Technical Bulletin / Safety Alert

Unique ID No: GEN2012-TBSA-02

Subject: Driftrunner Steering Valve Installation

Applicable to: All VLI Driftrunner Vehicles

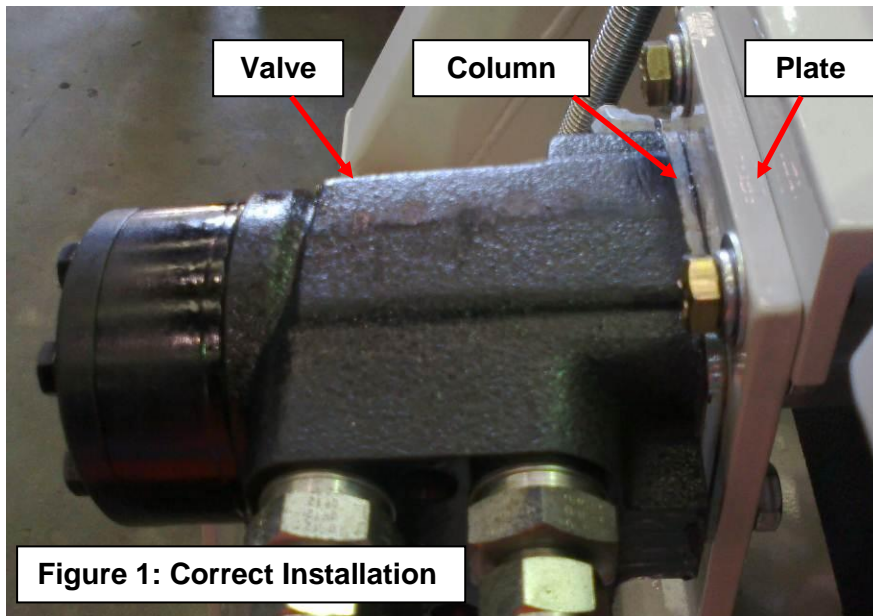
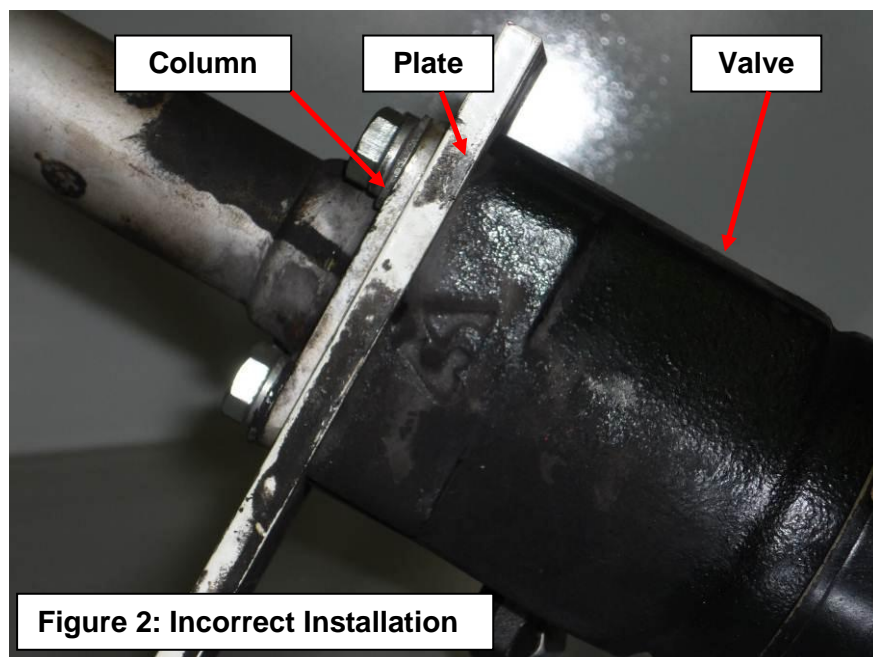
It has been identified that on some Driftrunner Vehicles, the steering column installation to the steering valve has been incorrect.

The incorrect method of mounting the steering column to the steering valve is shown in Figure 2, where the mounting plate has been placed between the steering column and the steering valve. This installation method reduces the length of engagement of the steering column pinion to the steering valve gear, potentially affecting the steering response of the vehicle.

The steering column is to be mounted directly to the steering valve, and then to the mount plate, as shown below in Figure 1.

End users should immediately inspect all Driftrunner vehicles to verify correct steering valve installation.

Vehicles with incorrect installations should be removed from service immediately and installation corrected.
